**Flood Control Project Maintenance
Levee Inspections**

Maintenance Issue Types Only, Levee Inspection Report By Mile - Spring 2015

San Joaquin County Flood Control and Water Conservation District

Photo 1 of 1 : SP_2015_NA0017_152_1075_20150313_00087.jpg

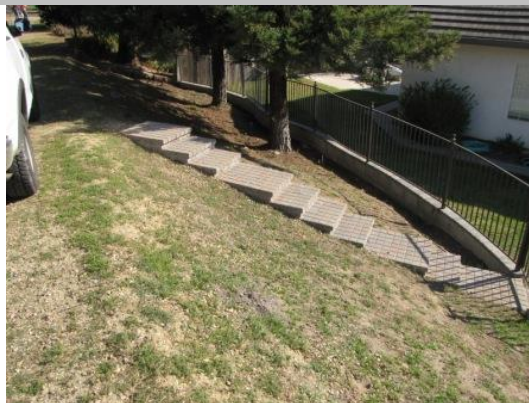
LM Start	0.80	Rating **	M	Issue No.	1075
LM End	0.80	Issue Type +	Ma	Location *	LS
Category	Earthen Levee			GPS Latitude/Longitude	
				Start	End
Item	Encroachments			38.053178 °	38.053178 °
				-121.375387 °	-121.375387 °
DWR ID	DWR_NA0017_08_s_2012_1075				
Action/Comments					
Stairway

View of steps on the landward slope looking upstream.
